**Marion County
Board of County Commissioners**

**PLANNING & ZONING SECTION
STAFF REPORT**

P&ZC Date: 11/25/2024	BCC Date: 12/17/2024
Case Number:	241210ZP	
CDP-AR:	32028	
Type of Case:	Rezoning from General Agriculture (expired PUD) to PUD to allow for a total of 157 residential units	
Owner	GPK Ocala One, LLC	
Applicant	Tillman & Associates Engineering, LLC	
Street Address	No address assigned	
Parcel Number	36640-004-00	
Property Size	±39.36 acres	
Future Land Use	High Residential (HR)	
Zoning Classification	General Agriculture (A-1)	
Overlay Zone/Scenic Area	Primary Springs Protection Zone	
Staff Recommendation	APPROVAL WITH CONDITIONS	
P&ZC Recommendation	APPROVAL WITH CONDITIONS	
Project Planner	Eryn Mertens, JD, Planner II	
Developer's Agreement	None	
Related Case(s)	160504Z (expired PUD)

**Figure 2
Conceptual Plan**

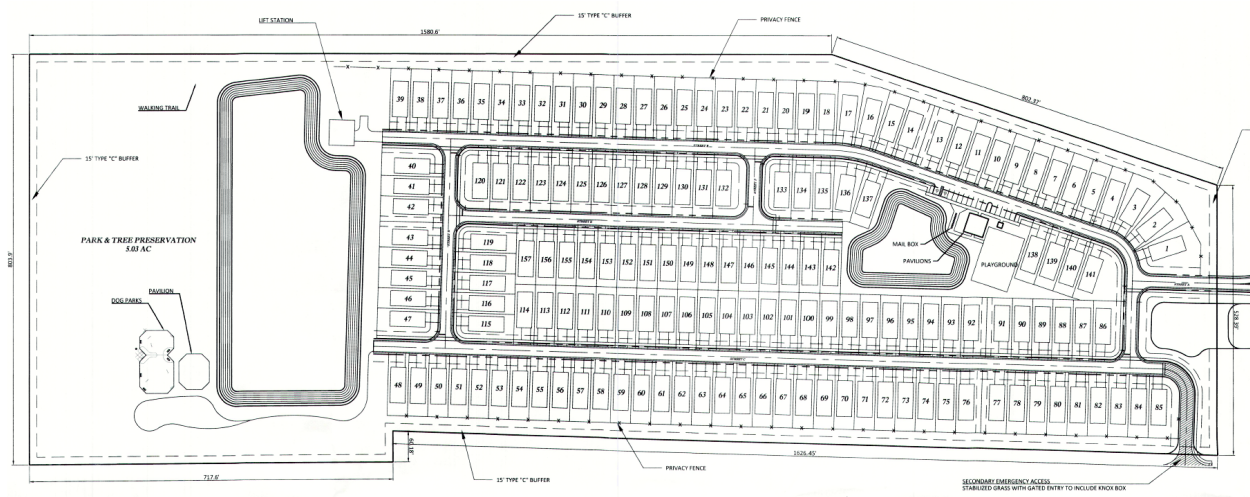
The PUD does not address the heights of the homes along the southeast and southwest border. There is only mention in the concept plan and renderings of two-story units. One-story units would be more appropriate along the boundaries of the project that border one-story single-family residential lots to stay consistent with the neighboring single-story units, reserving the internal units, and the units along the rights of way for the two-story units.

Analysis: The application proposes a modified Type C Buffer around the perimeter of the project. The modified Type C Buffer includes 2 shade trees, 3 accent trees per 100 linear feet, shrubs, and ground cover. Growth Services staff is unable to determine what the proposed modification is with the Type C Buffer of the Marion County Land Development Code. While not in the buffers, the Conceptual Plan shows a 6' opaque fence at the rear of the property lines internal to the site but not within the buffer area. This will add additional visual screening of the project from adjacent properties. Due to staff being unable to determine what modification is proposed, staff recommends the following condition.

However, the PUD does propose additional parking at the small neighborhood park, and the park is within walking distance of the entire PUD. Currently the Conceptual Plan proposes the parking spaces at the playground to back out into the subdivision road. Comments from OCE-Traffic do not address this but will address this issue during the Site Plan or Improvement Plan stage of Development Review.

- A Type C Buffer shall be installed along all property lines. Existing vegetation may be counted toward the buffer requirements if approved by the Marion County Landscape Architect or designee.
